**From:** Scala, Mary Joy  
**Sent:** Tuesday, August 25, 2015 2:47 PM  
**To:** 'Clark Gathright'; hunter@huntercraigcompany.com  
**Subject:** BAR Action- August 18, 2015 - 1413-1/2 University Ave

**Certificate of Appropriateness Application**

BAR 15-08-02

1413 ½ University Ave.

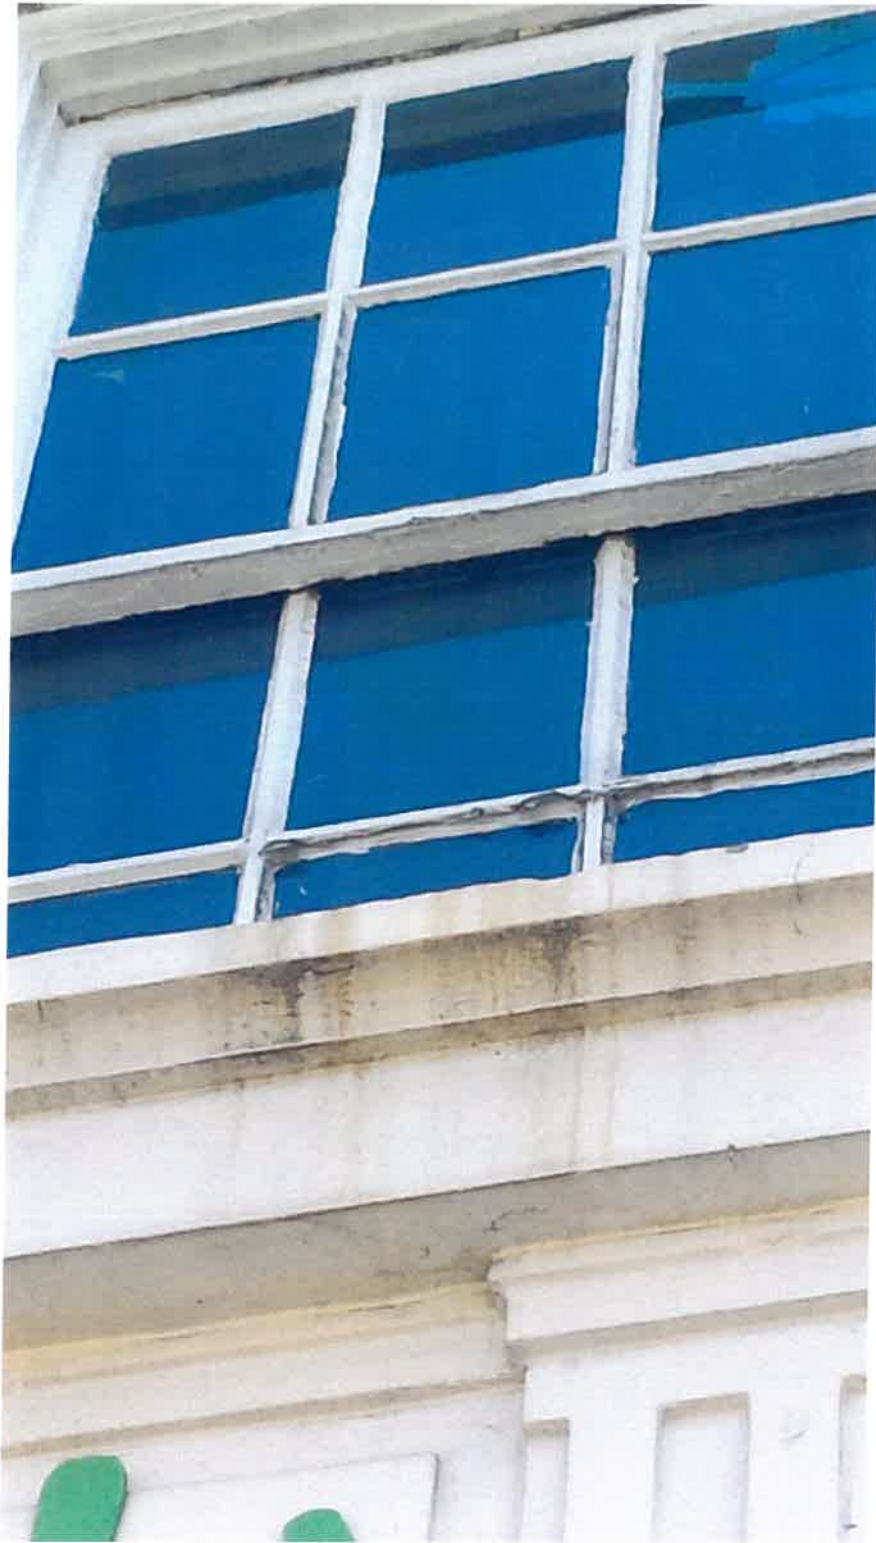
Poor condition of sash and stool.

Sill and trim condition - Replace wood sill and trim precast sill to remain

Disrepair of exterior glazing

Sash cords are missing at most windows

Many sashes are screwed together

NEW FLOOR PLAN - SECOND STORY OF CHANCELLOR BUILDING

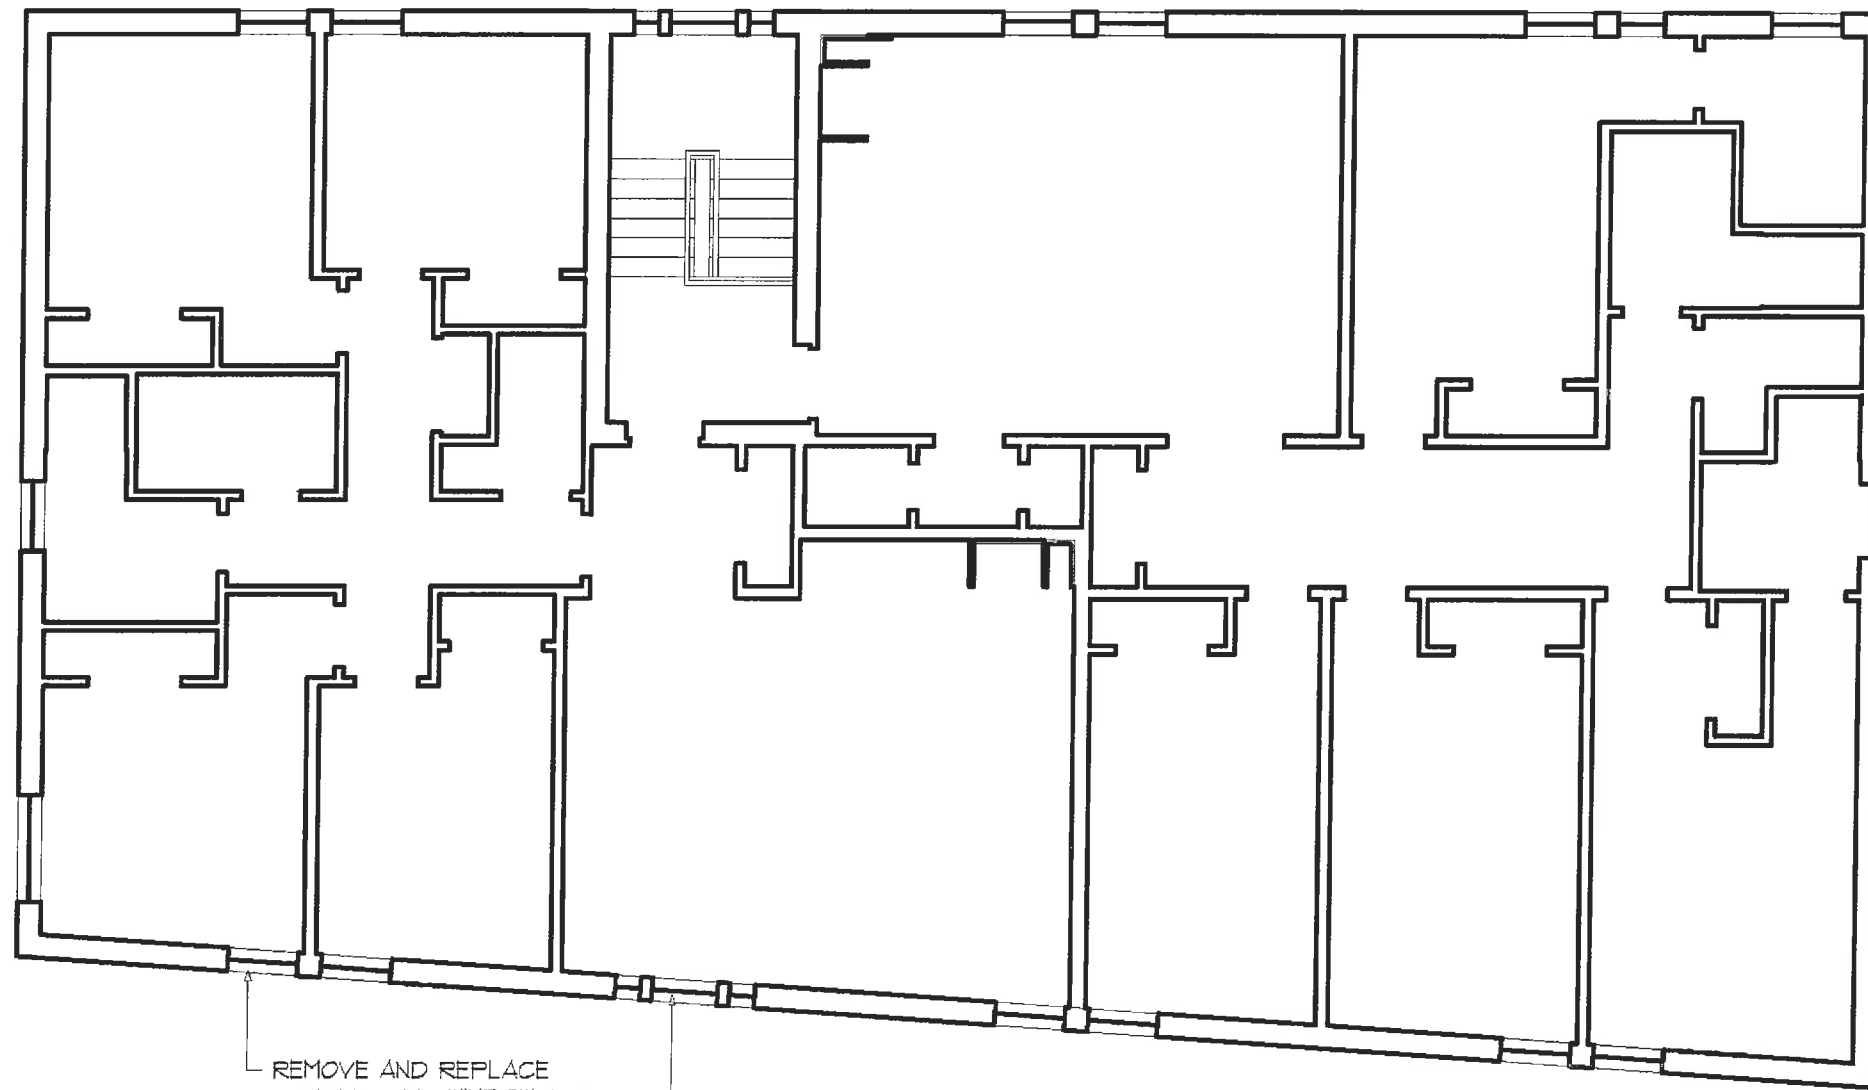
1. Which specific windows on the second story are you planning on replacing? If it is all of them, exterior elevation photographs of the windows being replaced are needed. Also, if you could note them on the second story floor plan, that would be helpful visual reference to include in the application.
2. What company is making the windows? Please specify that the glass will be clear.
3. The BAR may ask for more justification as to why you need to replace the windows, rather than repair them.

REMOVE AND REPLACE  
DOUBLE-HUNG WINDOW, TYP.

All of the second story windows will be replaced. The pictures include all of the windows, at least in part, in the submittal. (The building exterior is difficult to photograph due to the adjacent buildings). I provided a note on the second floor plan to remove and replace double-hung windows, typ. All of the second floor windows are double-hung windows.

WINDOW LOCATIONS, SECOND STORY OF CHANCELLOR BUILDING

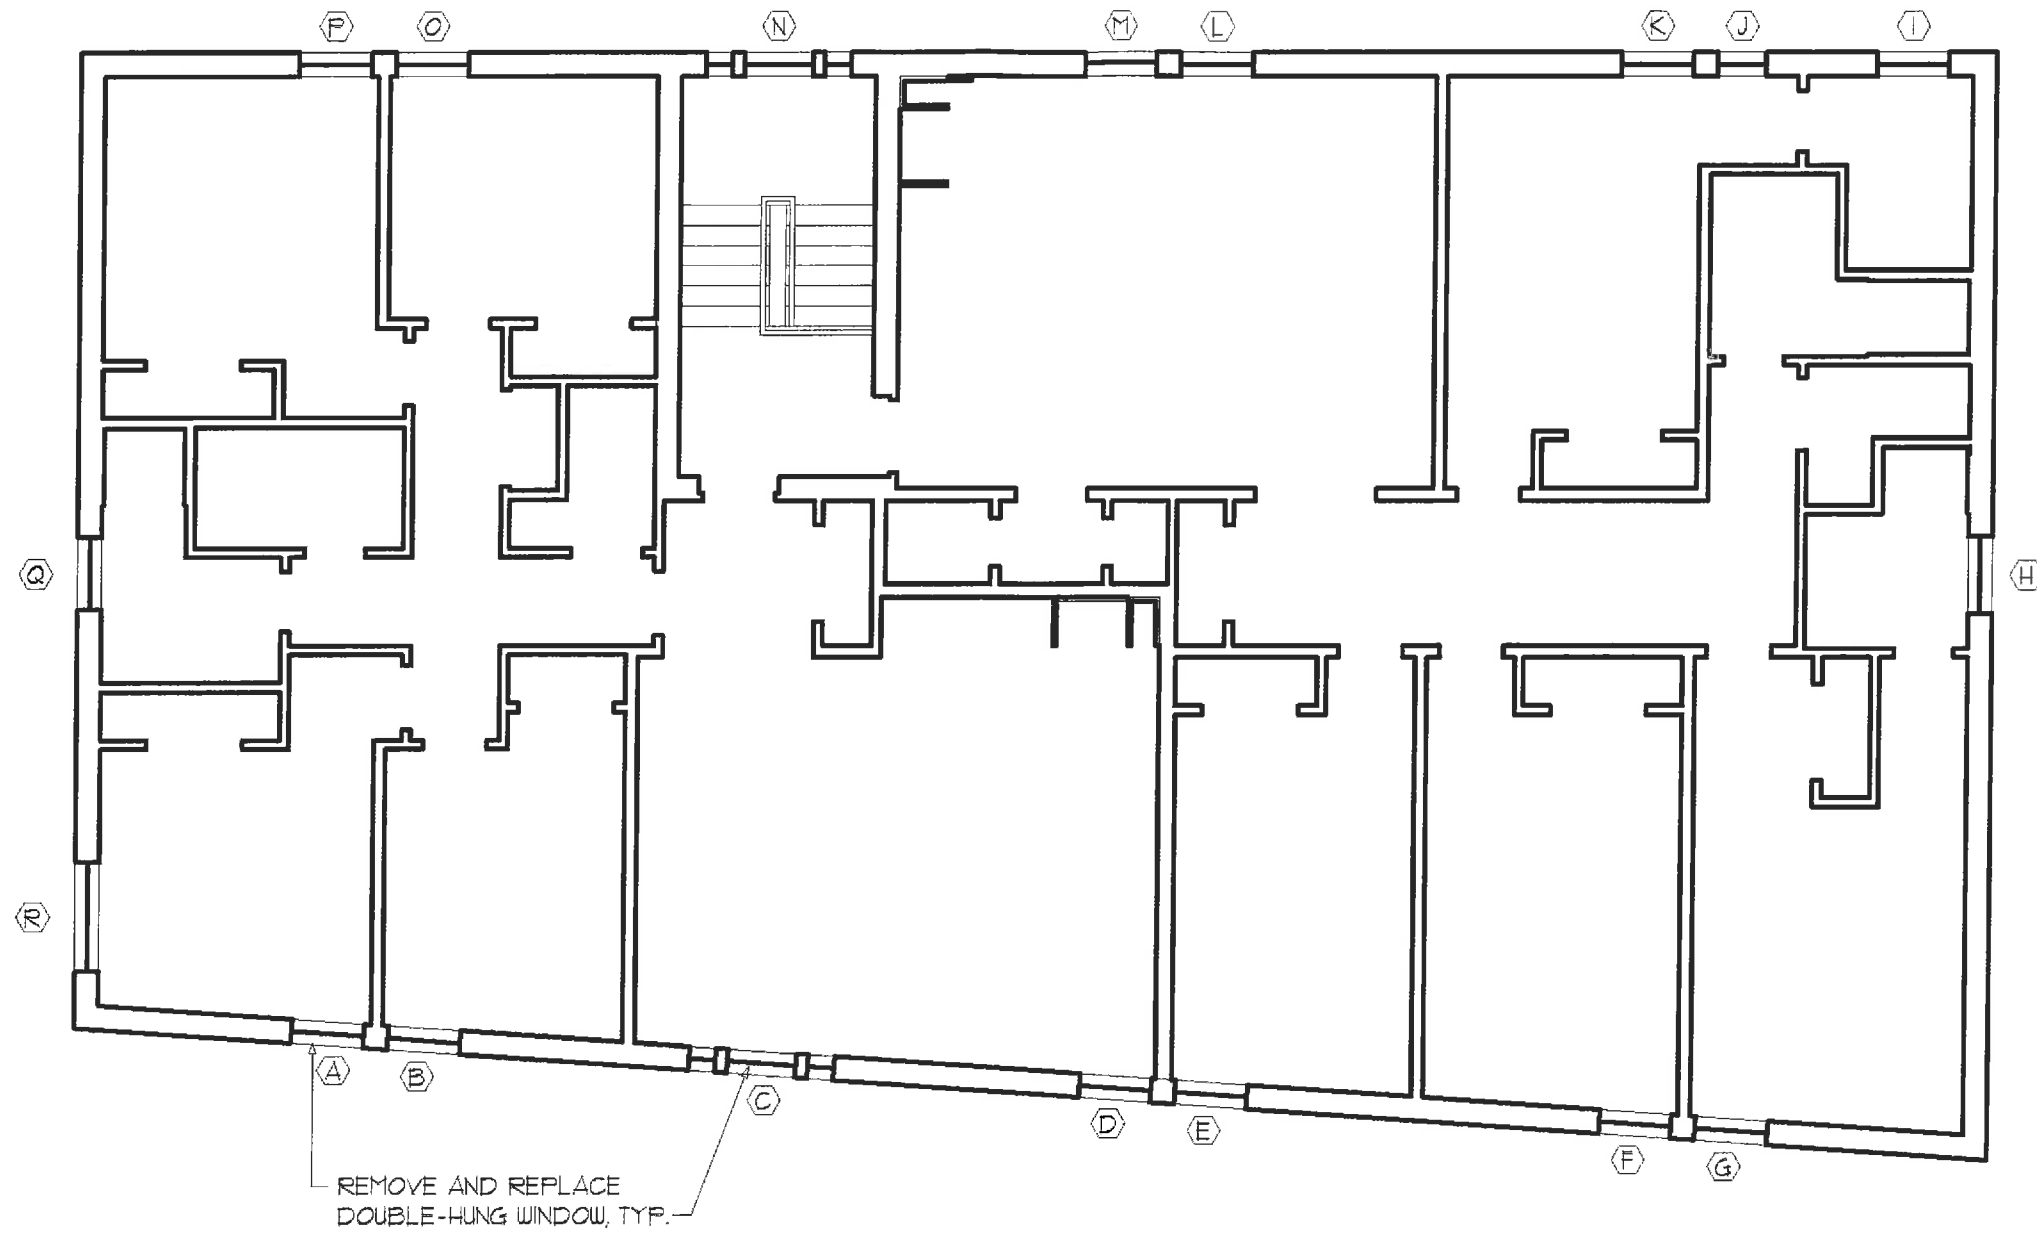
**The BAR approved (6-1, with Ms. Miller opposed) to repair windows A-H, and to repair window J, and to replace the remaining windows, raising their sills above the roof membrane. The BAR requested an elevation drawing of the replacement windows in relation to the roof (comparing existing and proposed) to be circulated to the BAR for administrative approval.**

**Please submit the requested elevation drawing before further work.**
